## Able UK Ltd

Your Ref: AN/2012/113982/01-L12

Our Ref: RC.LH.A.L12-0659

### **RESPONSES TO EA LETTER OF 9<sup>TH</sup> NOVEMBER 2012**

**Figure 10 Indicative gravel thickness during (top) and after (bottom) placement of material at HU080**

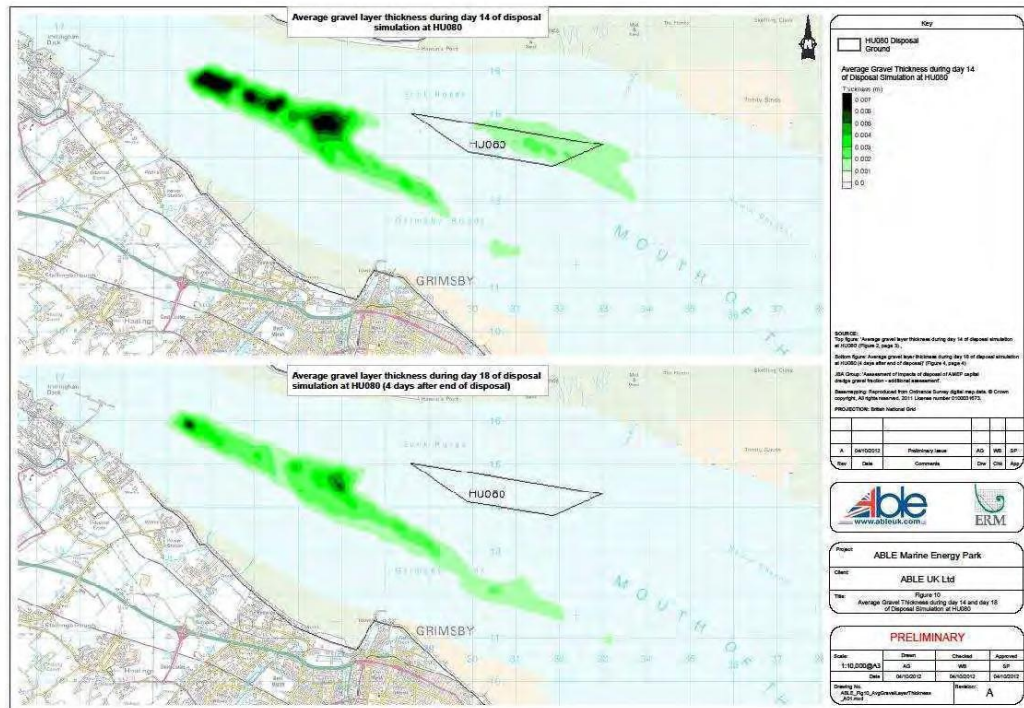
Changes to the assessment of the dispersion of gravel from disposal site HU080 have been made (set out in EX10.8a, included as Annex 2 to this letter – this is the report which was circulated by Richard Cram on 15<sup>th</sup> November, with the issue dates updated). The gravel is assessed to disperse more slowly than predicted by the modelling. It is also noted that the model results are averaged over 250m by 250m cells and hence an average layer of 8mm over a 250m by 250m cell represents a gravel volume of 500m<sup>3</sup>. If this gravel were mixed into an active transport layer of thickness 100mm of sandy material it would imply an 8% gravel content in such a layer. If the gravel were dispersed to a more stable area of mixed material the additional gravel could be considered as a layer of gravel – but noting that some gravel particles could be larger than 8mm in size.
